SECTION A-A

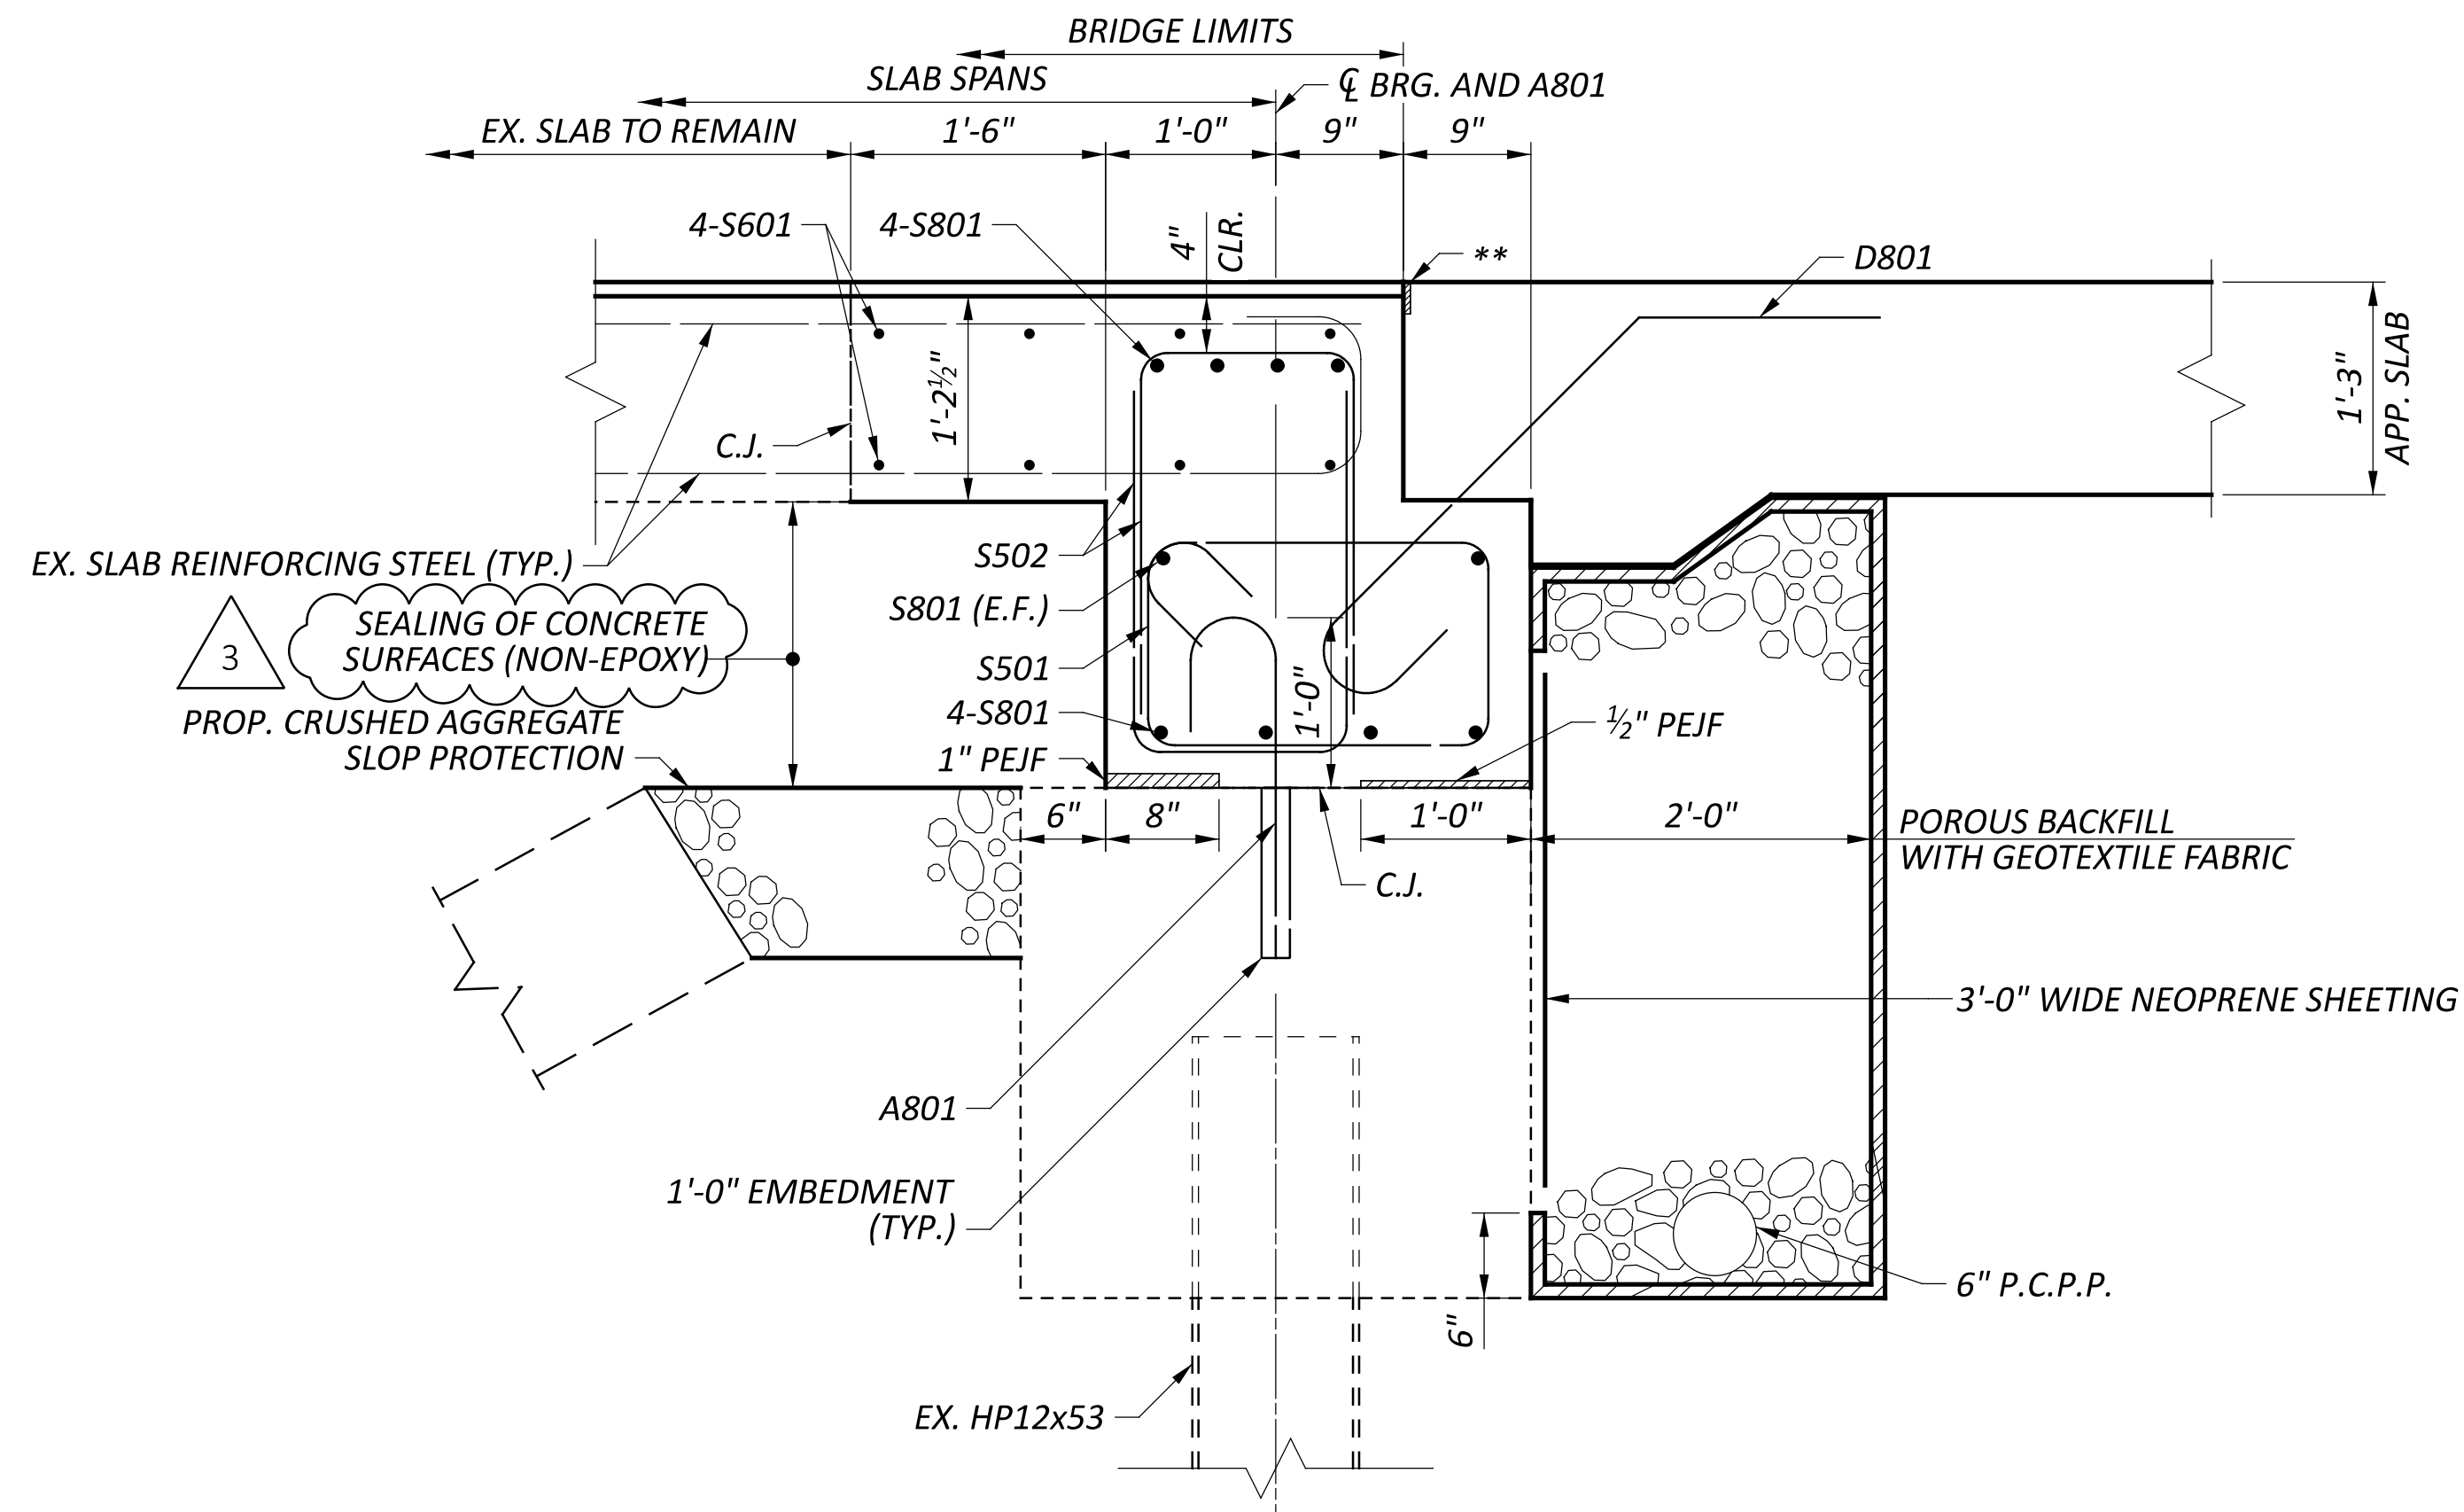
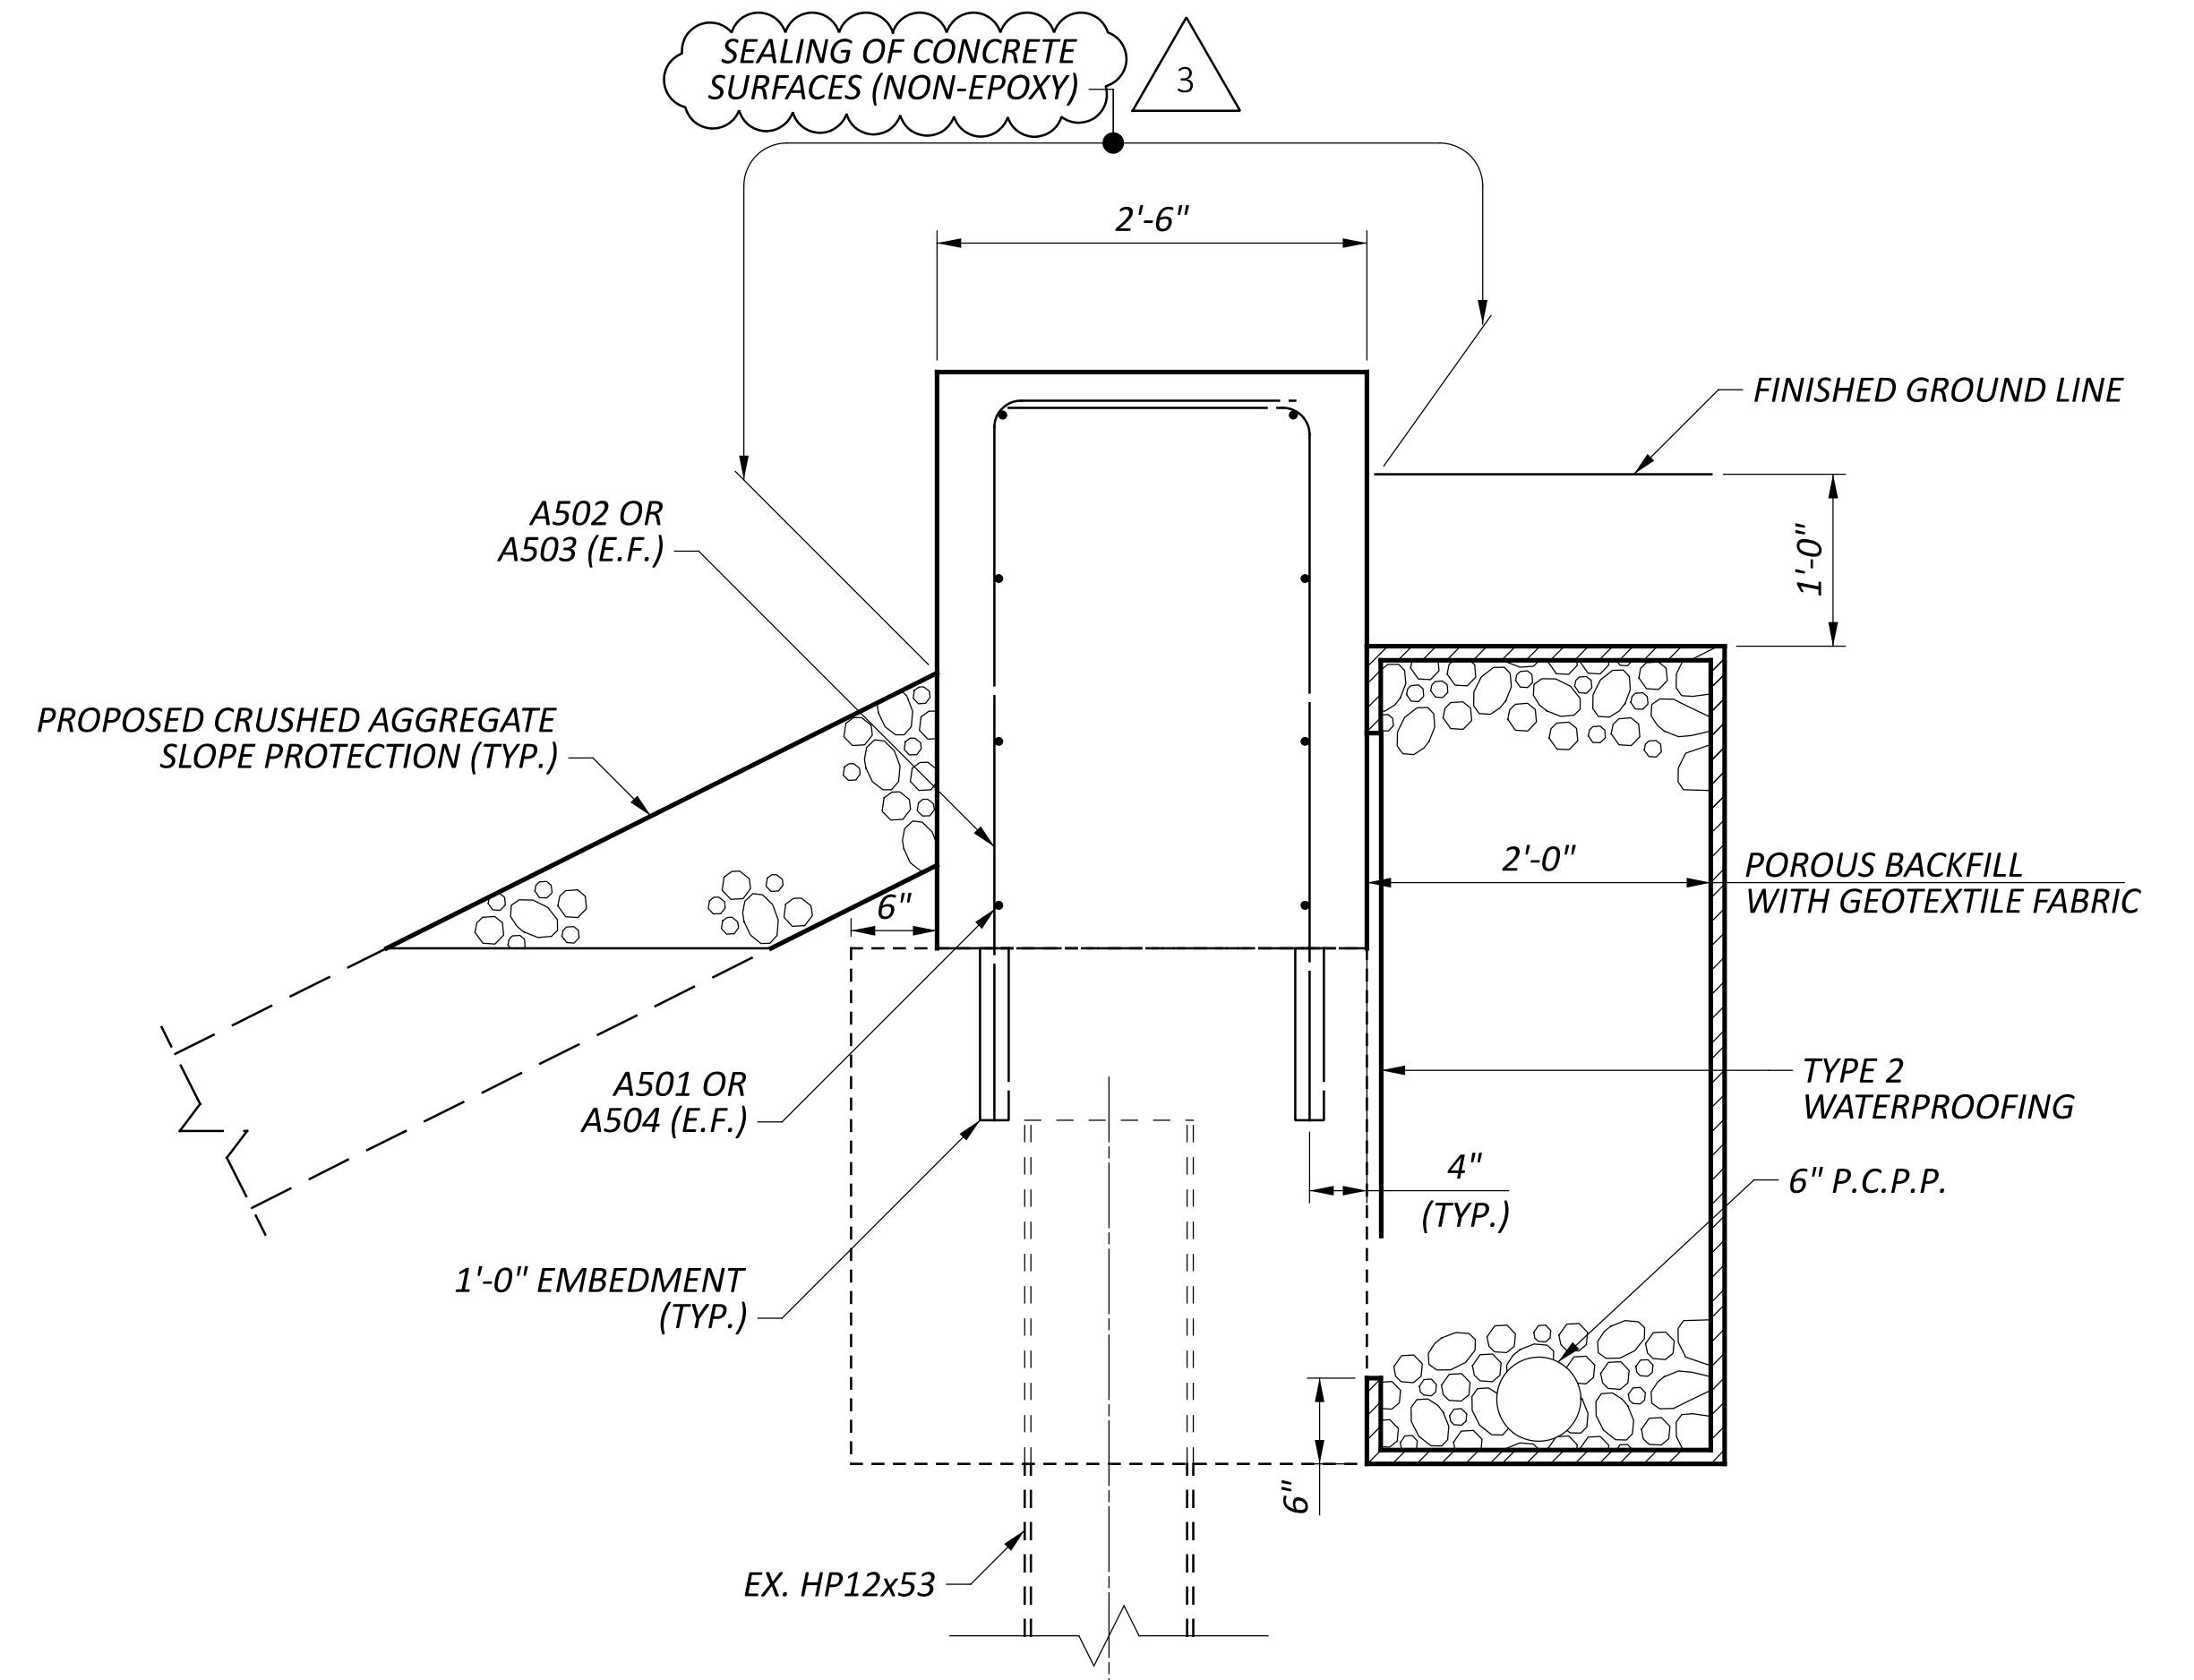
| REVISIONS | | |
|-----------|-----------|---|
| 3 | 1/27/2025 | CHANGED ITEM 512 FROM EPOXY-URETHANE TO NON-EPOXY |
